SERVICE BULLETIN

DOCUMENT: AFS-SB8

REVISION: 2

CARBURETOR THROTTLE BODY TO BOWL RETAINING SCREW INSPECTION

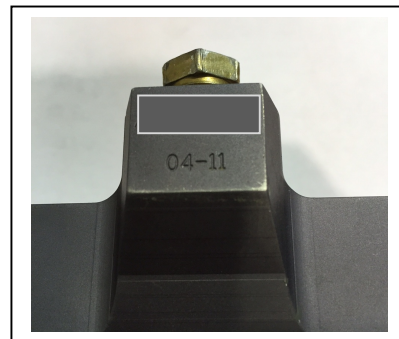
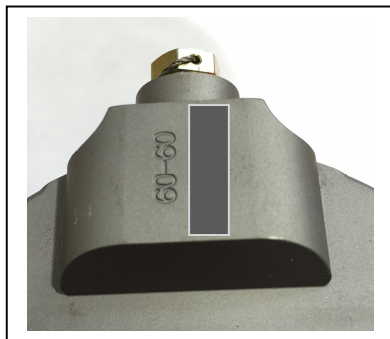
This Service Bulletin applies to all LVC-3-3A, LVC-3-3PA, LVC-5-4PA, LVC-5-5BPA, LVC-5-5PA, and all legacy aircraft carburetors manufactured by AVStar Fuel Systems, Inc. pre-dating August 2012 notated by date code on bottom of carburetor bowl near drain plug. See examples of date code below (part number covered for clarity). Service Bulletin in effect until overhaul or serviced per bulletin.
